## M25 junction 10/A3 Wisley interchange

TR010030

### 9.58 Applicant's Response to the Examining Authority's Second Written Questions

March 2020

Figure 4.4h Lane drop diverge weaving section

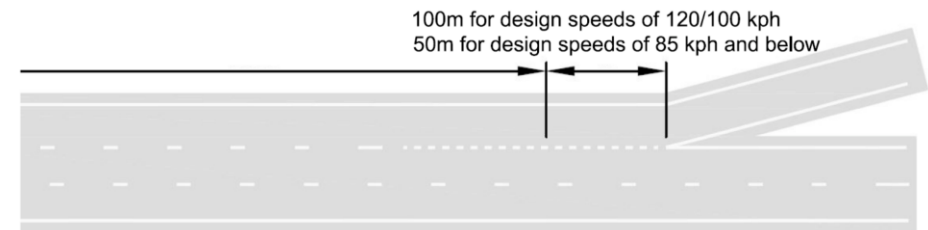
2.13.15	Applicant,	Where there is a junction between a multi lane dual	Generally, multi lane carriageways would be required where there are high

Question Number	Question to:	Question	Highways England Response
<b>13. Traffic, transport and road safety</b>			
	SCC and RHS	<p>carriageway and a side road how does the number of lanes on the dual carriageway affect the propensity for weaving to take place? The answer to this question should be given in general terms and should therefore disregard any local circumstances relating to the Proposed Development.</p>	<p>forecast volumes of traffic. Where there is a high volume of traffic on the main carriageway diverging off the road towards an exit slip road and a high volume of traffic from a junction slip road joining the main carriageway there will be more weaving traffic and an increased risk of conflicts between vehicles and hence a likelihood of more accidents.</p> <p>The diagram below shows a modified (without text) figure of the possible weaving movements: (See CD122, Figure 4.7N5 (extract included within document TR0130030/EXAM/9.67)).</p>  <p>The likelihood of accidents is increased where the volume of exiting traffic requires lane drops on the main carriageway as traffic joining from the junction slip road needs to move over several lanes to continue along the main carriageway causing more conflicts with the weaving traffic.</p> <p>The diagram below shows the lane drop diverge. (See CD122, Figure 4.4h).</p>

Where a side road is a single (one lane in each direction) carriageway road and a multi lane dual carriageway to a 3+ lane (in each direction) dual carriageway, then weaving should not occur because this type of arrangement is not permitted by the DMRB.

However, where a 'side road' is a slip road leading to or from an at grade or grade separated junction then the effect on the propensity for weaving is as follows:

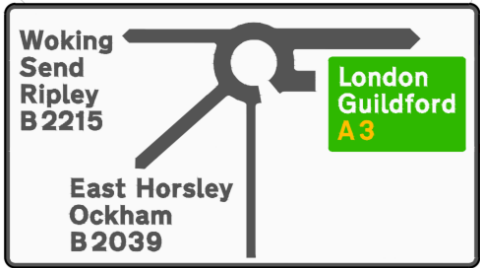
<p>c) With respect to the consideration of the potential for weaving to occur and whether the provision of a side road access would or would not be safe, what significance is to be placed on the time of</p>	<p>It would be reasonable to expect vehicles to be travelling at higher speeds on the mainline during the interpeak, which would make it difficult for slow moving vehicles to merge and weave across the lanes because of the speed differential, which would increase the risk of side swipe accidents.</p>

Question Number	Question to:	Question	Highways England Response
<b>13. Traffic, transport and road safety</b>			
		day, ie during peak or inter-peak hours, when the majority of the weaving may arise?	During peak hours the mainline traffic speeds are likely to be less but the volume of traffic would be greater, so whilst there would be less opportunity to weave across the lanes and shunt type accidents would be more likely.
